RANDY M. GOODLOE, AIA, APAC
A Professional Architectural Corporation

Project: Barbe – Gyms & Cafeteria Repairs, Modular Installation

Addendum No. 4

6 BASE BID - WALL SECTION - BLDG M - BASE REPAIR
1/2" = 1'-0" (REF: 1 / A-201)

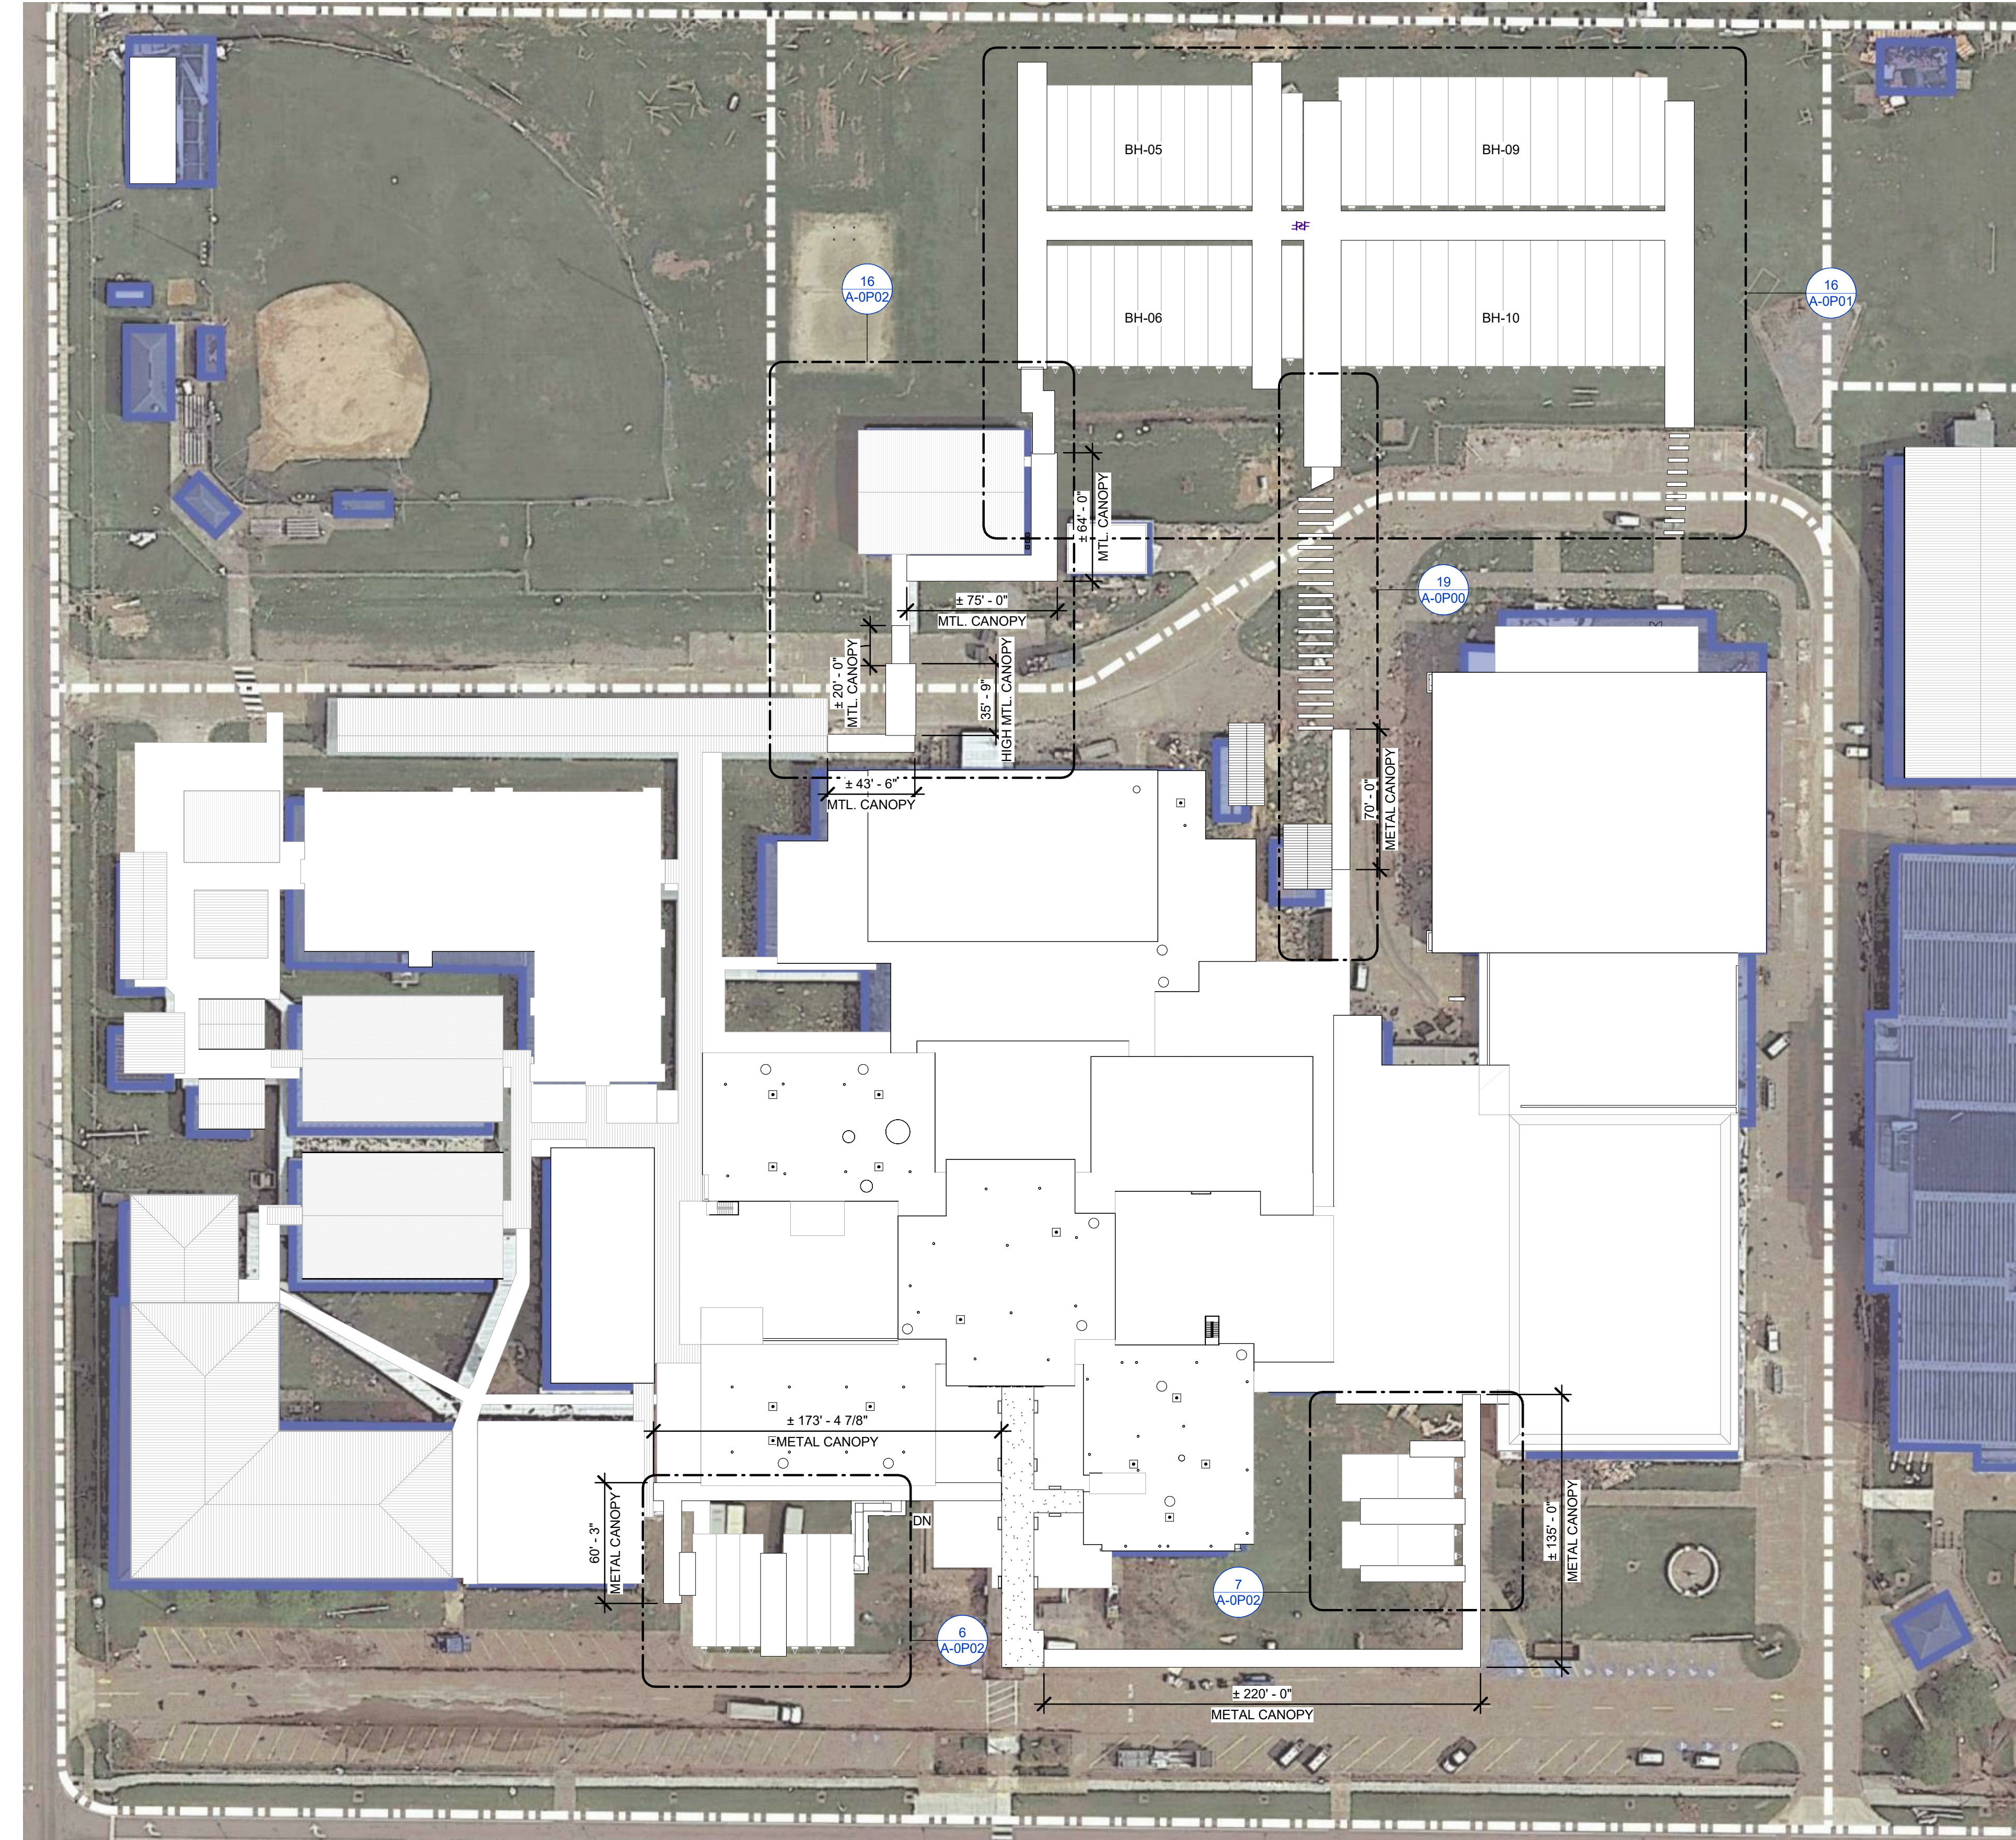
- Item No. 8 - See attached specification 07 42 13.53 Metal Soffit Panels.
- Item No. 9 - See attached revised detail 6 of sheet A-001.
- Item No. 10 - See attached revised sheets A-OP00-A-OP08.

- Item No. 15 - Question: Detail 6 A-001 above the existing 24 WF 68 steel beam it calls for the existing Tectum between joist to be removed and replaced. Need a clarification if this is part of the Tectum roofing system or is it part of the Tectum wall panel system.

- Response: The entire Tectum Roof system in the Boys Gym area is to be removed and replaced as specified in the Architectural & Structural Drawings. Tectum wall panels are a separate item. See revised details this addendum.

GIRL'S GYM WALL DETAIL - N.T.S.

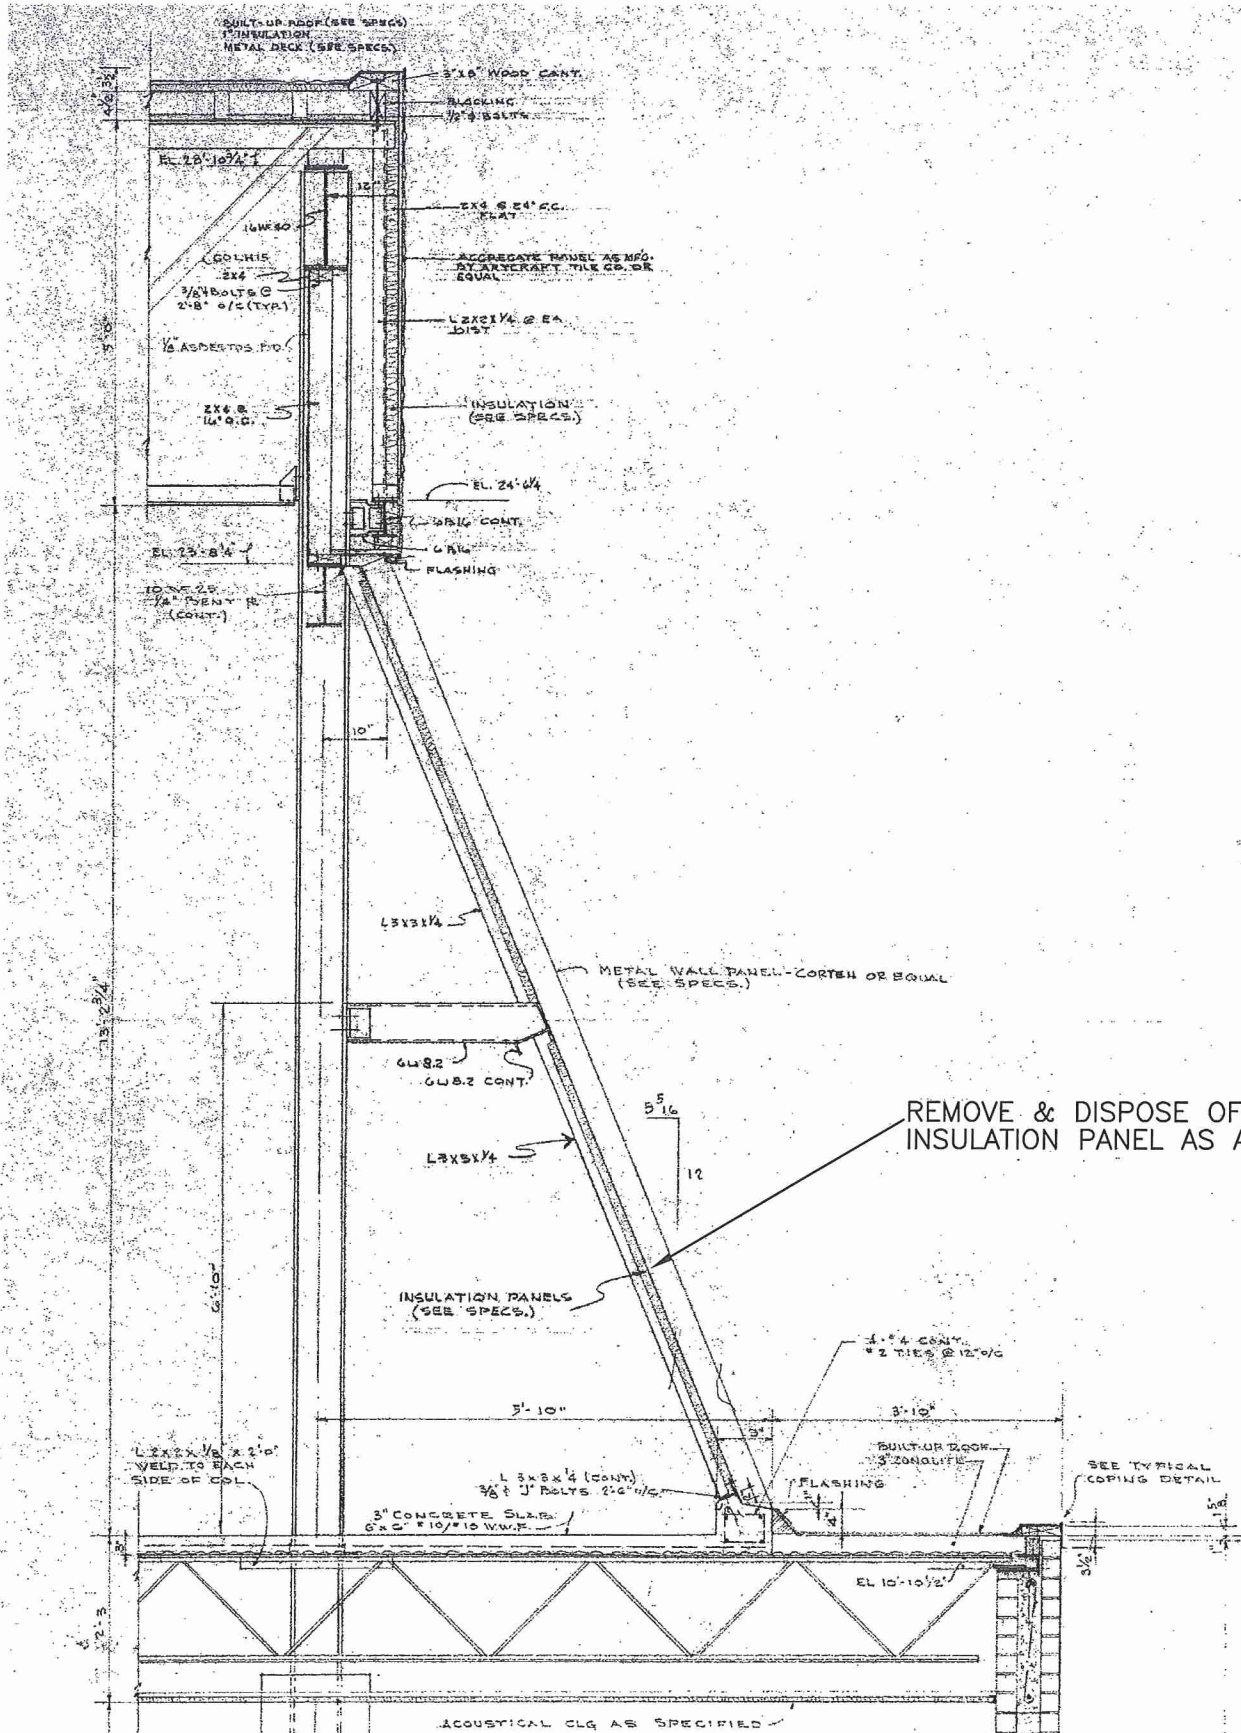
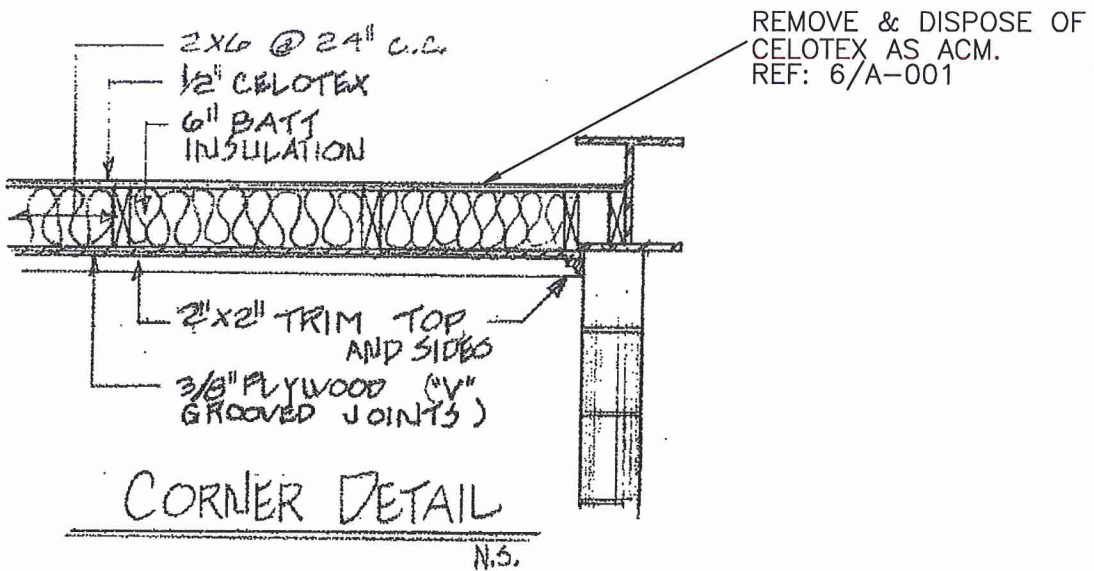
Item 1 Contractor shall demolish and dispose of materials as required to access asbestos containing materials. Contractor shall remove and dispose of as regulated asbestos containing materials all soffit materials beneath aggregate panels removed during work of this project. Contractor shall remove and dispose of Celotex as asbestos containing materials. Coordinate demolition and abatement phasing with General Contractor as required.

REMOVE & DISPOSE OF INSULATION PANEL AS ACM.

REMOVE & DISPOSE OF CELOTEX AS ACM. REF: 6/A-001
